ADDENDUM NO. 2

Project Name: **INDIAN RIVER COUNTY COURTHOUSE PARKING GARAGE REHABILITATION
(IRC-1801A)**

DATE: August 27, 2020
FROM: REI Engineers
REFERENCE: **Specification and Drawing Update for Addendum No. 2**
Indian River County
IRC-1801 Indian River County Courthouse Parking Garage Rehabilitation

DRAWN BY: AD
SCALE: NOT TO SCALE
DATE: 07-28-2020
REI PROJECT NO: 019TPA-020
SHEET: S001
COVER SHEET

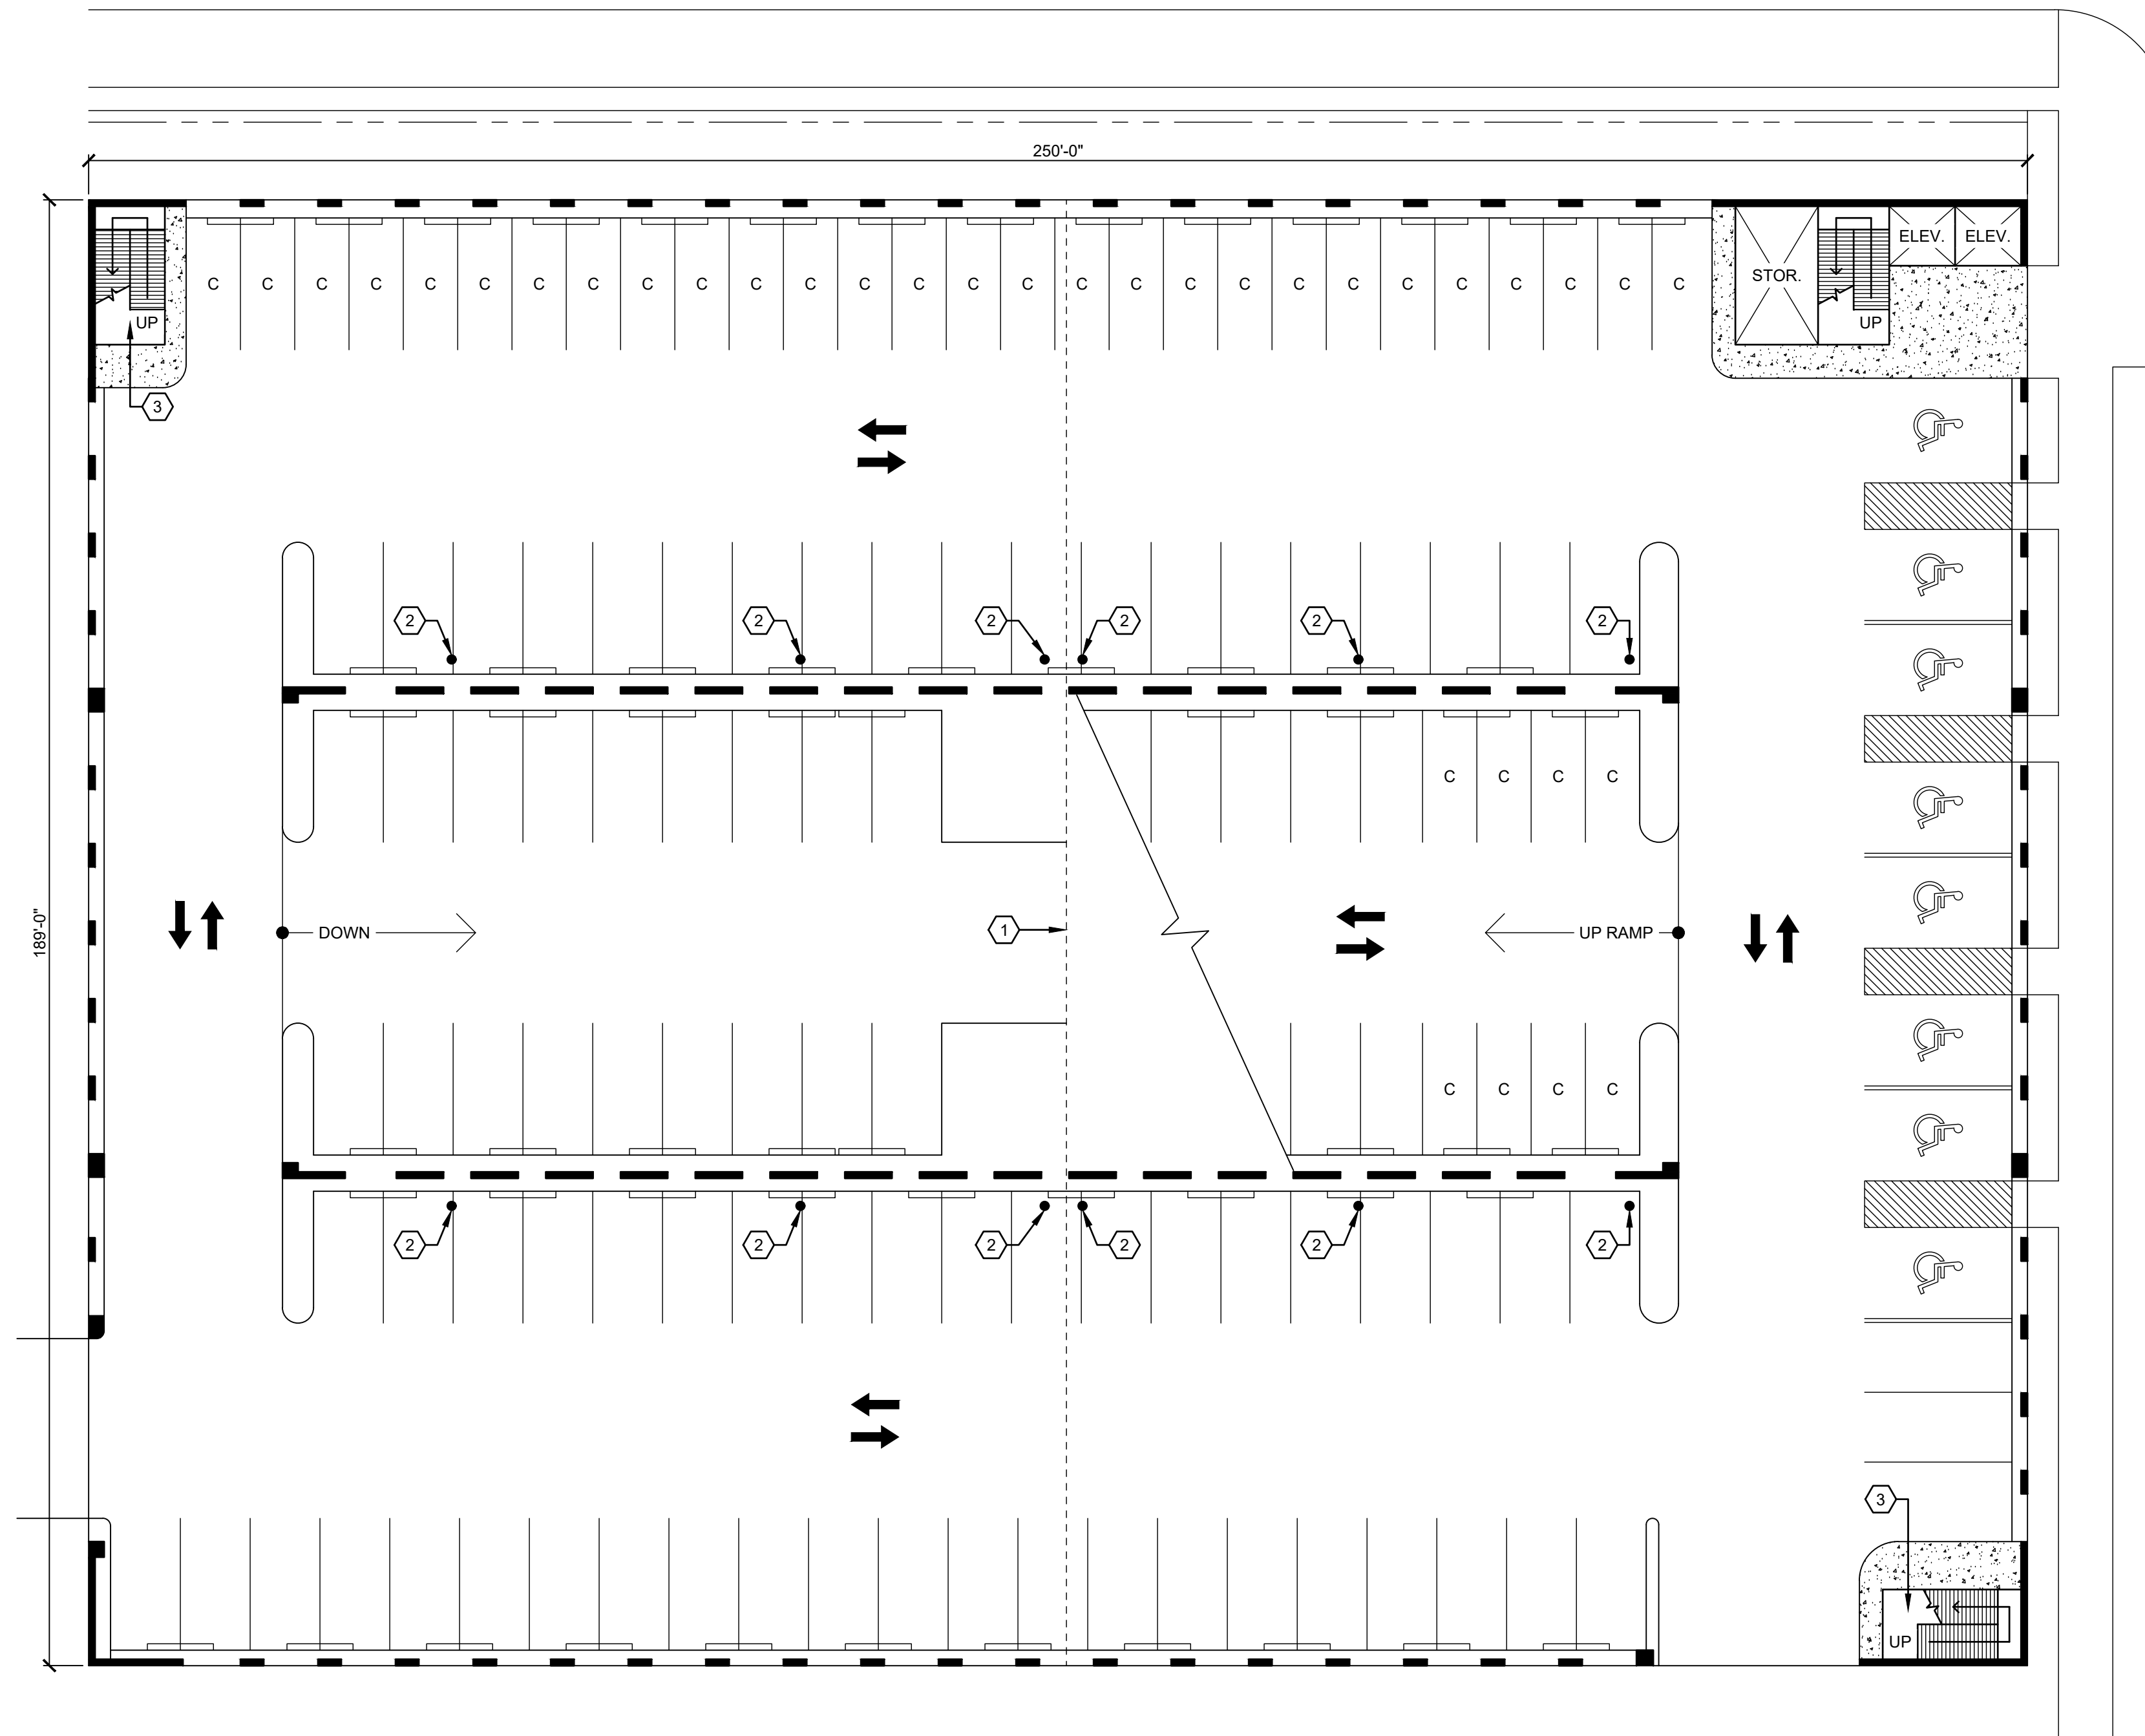
Question 11. S001 describes (4) drain bowl clamping rings to match existing and the bid form has a quantity of 24, plan on the 24 quantity?

Engineer's Response: Plan on 24 drain bowl clamping rings. Please reference the attached drawing update.

1. Replace Specification Section “Contract Drawing S001” with attached “Contract Drawing S001 (Revision No. 1)”. Contract drawing has been updated to modify the scope of work description.
2. Replace Specification Section “Contract Drawing S103” with attached “Contract Drawing S103 (Revision No. 1)”. Contract drawing has been updated to correct the elevator ceiling location.

- △ 10. CONTRACTOR SHALL REMOVE AND REPLACE IN KIND (24) DRAIN BOWL CLAMPING RINGS TO MATCH EXISTING AS INDICATED ON DRAWINGS.
11. CONTRACTOR SHALL INSTALL NEW TRENCH DRAIN LINER AS INDICATED ON DRAWINGS.

TRENCH DRAIN LINER SECTION

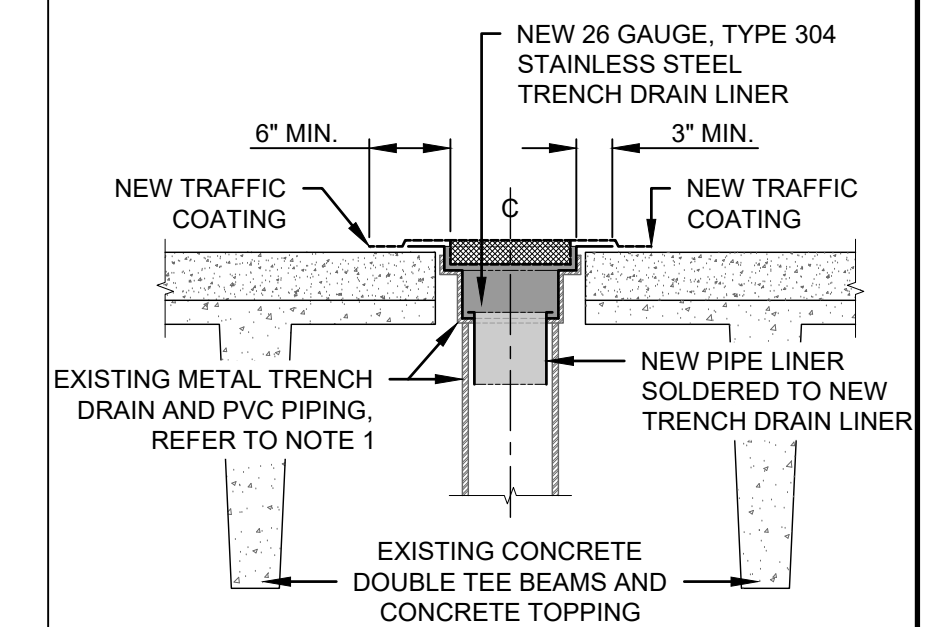
- Question 7. a. Is there a preferred manufacturer for the trench drain liner?
b. Are alternates to the Stainless-Steel Liner acceptable?

- a. There is no product we are aware of that can be used in this application.**
- b. Alternates may be evaluated.**

SHEET: S103
3RD FLOOR PLAN

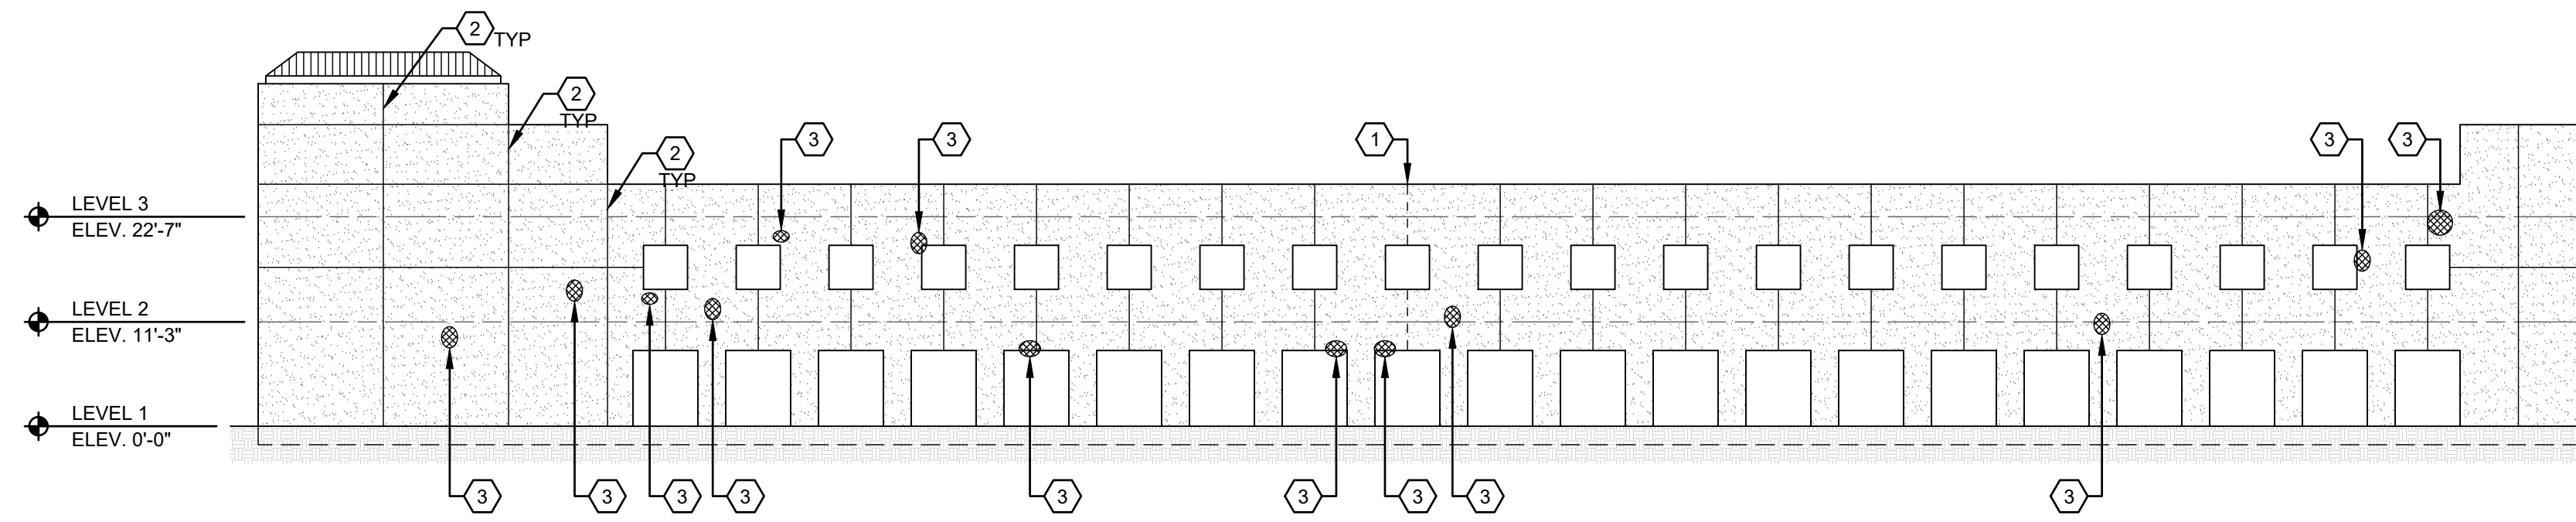
Question 3. Plans and specs calls for remove and replace sheetrock ceiling in Elevator Shaft. The location it is showing appears to no longer be an elevator? Is this the right location and if so how are we to access the ceiling?

Engineer's Response: Location has been updated to indicate the west elevator shaft. Please reference the attached drawing update.

SHEET: S201
ELEVATIONS

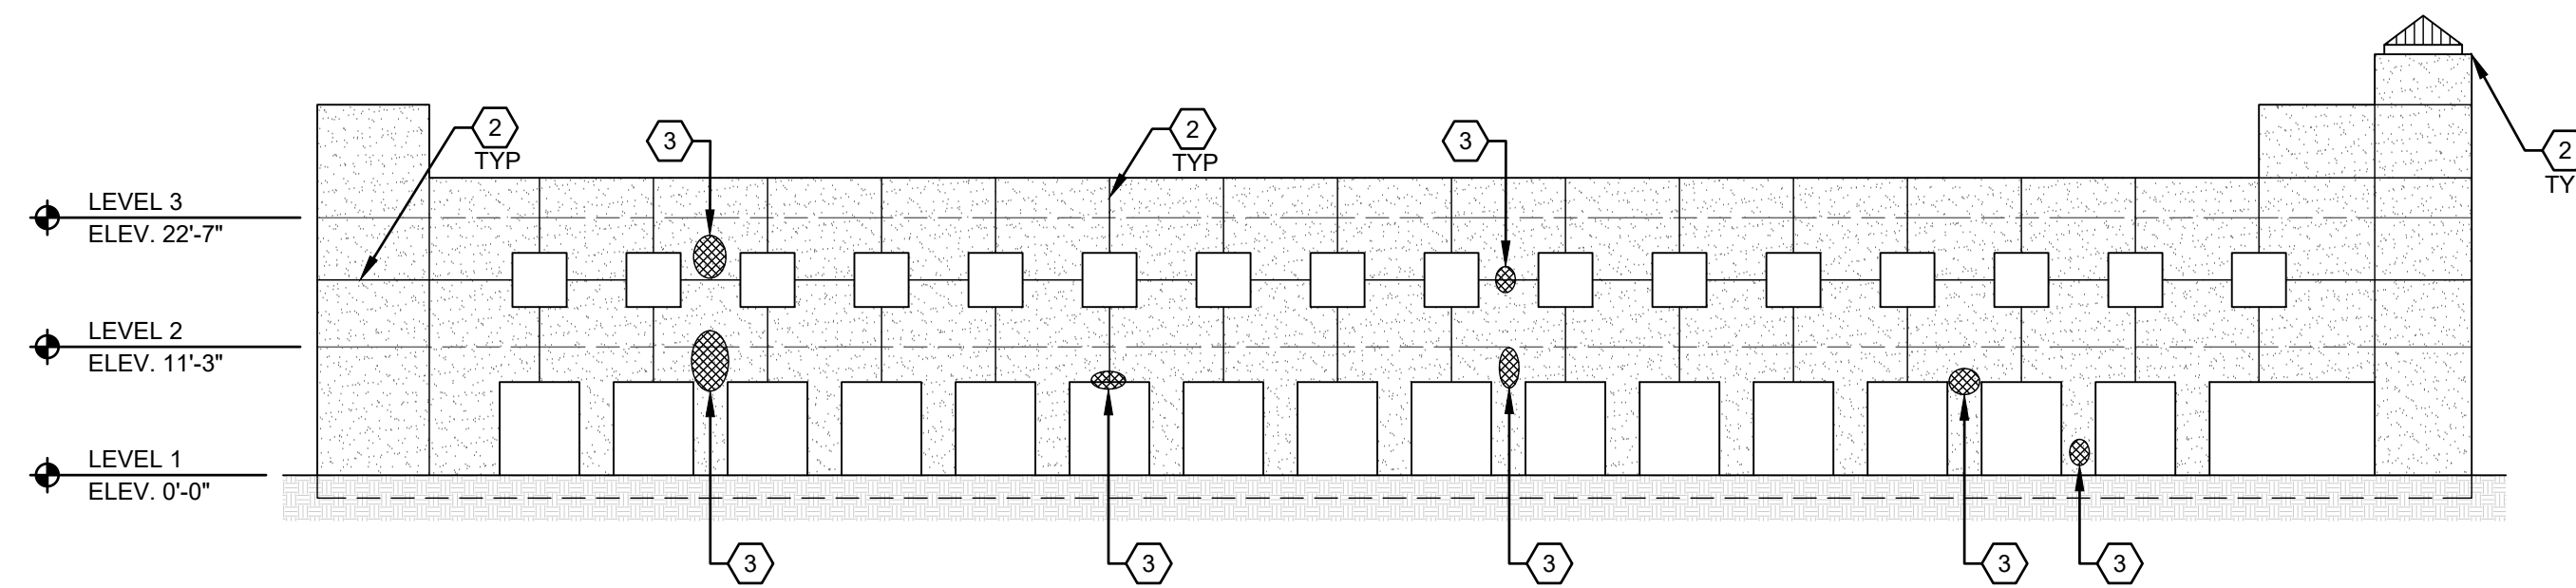
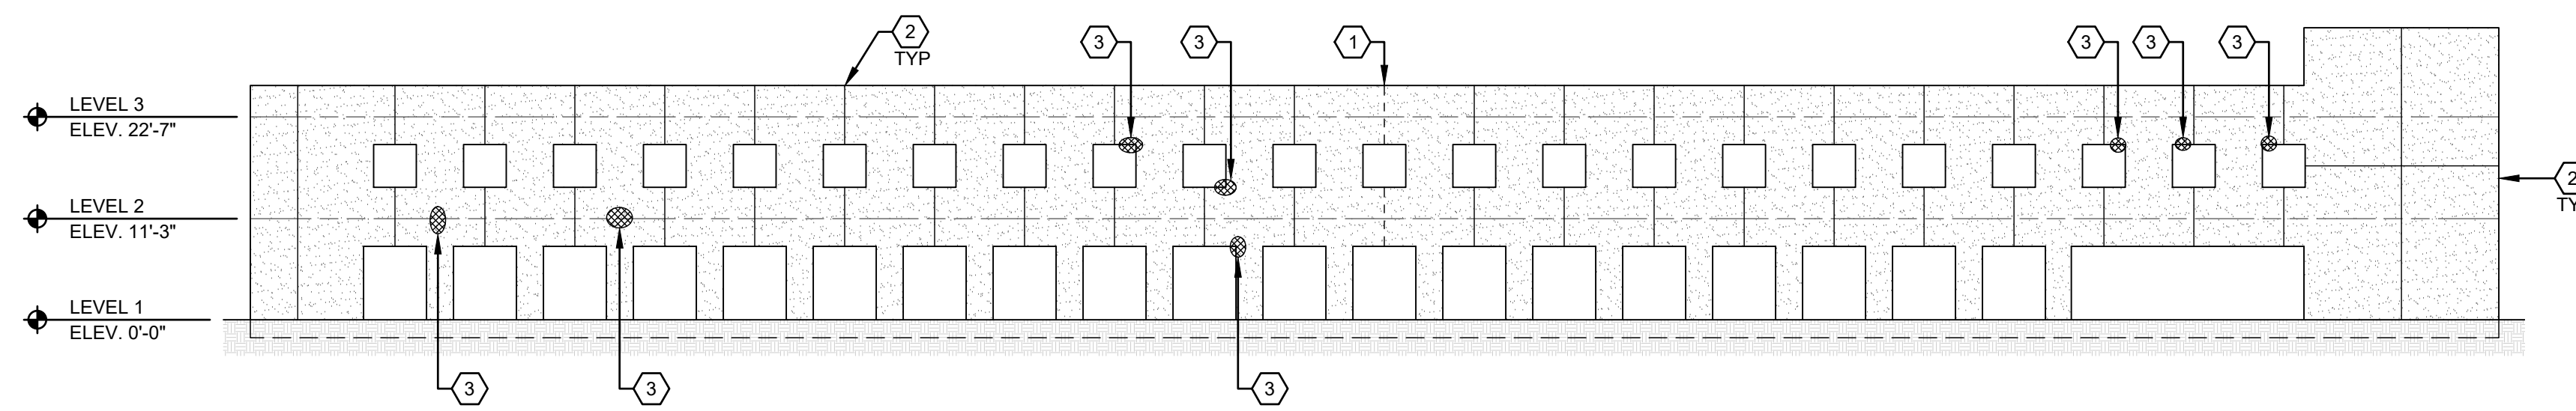
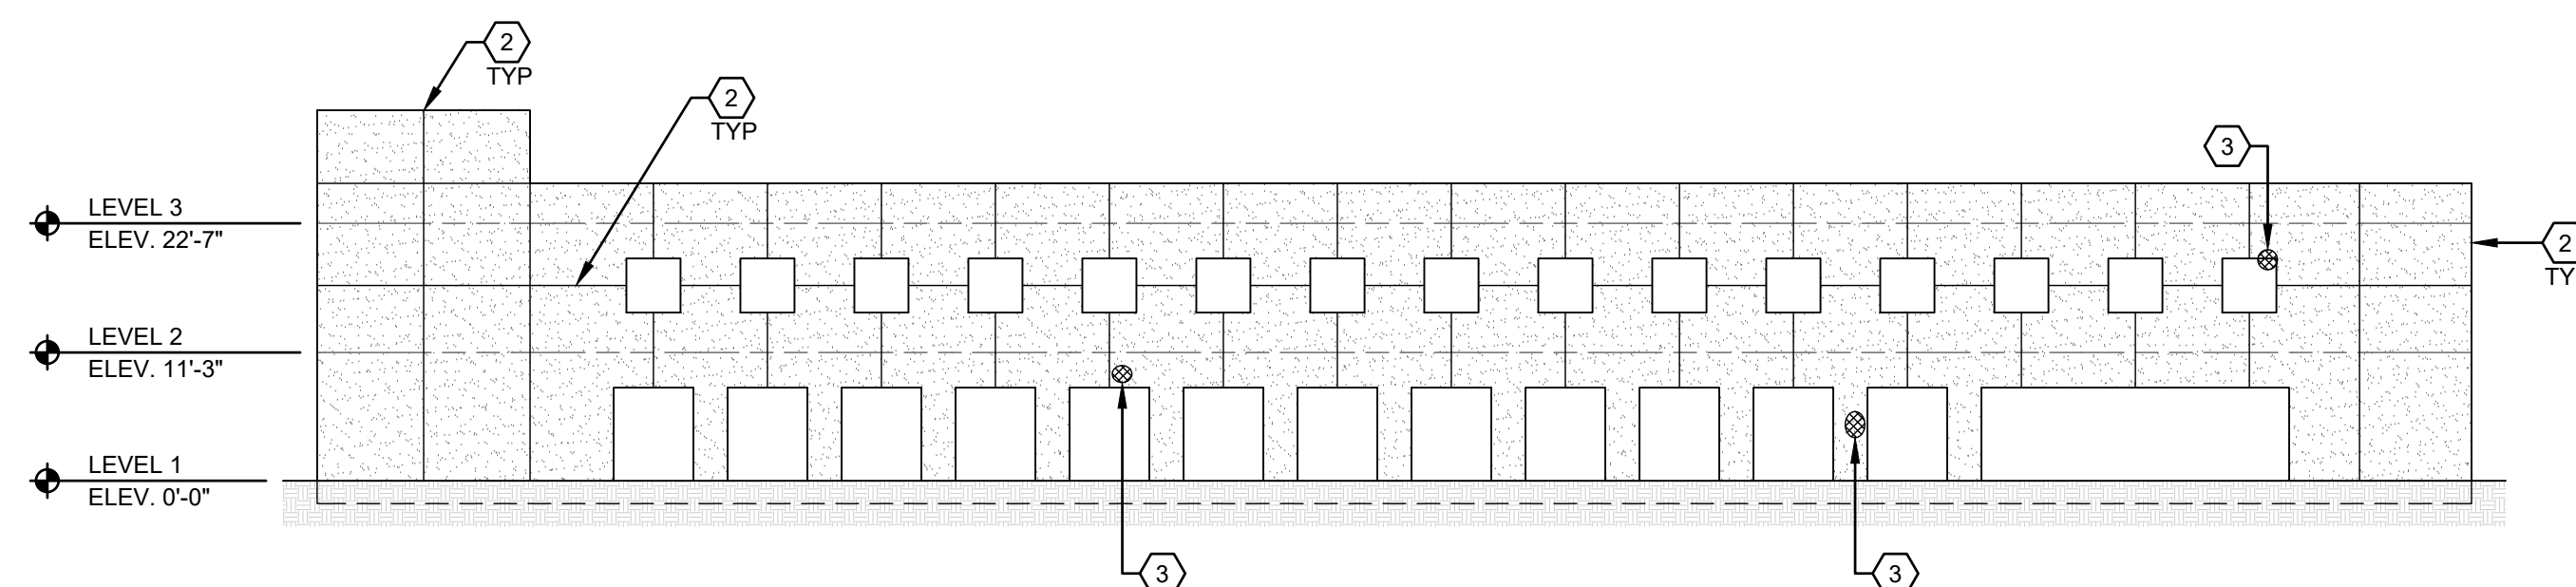
Question 17. On drawing S201, note 2 it refers to removing and replacing sealant but all points reflected do not currently have any in place. Is it your intent to seal all vertical and horizontal joints?

Response: Yes
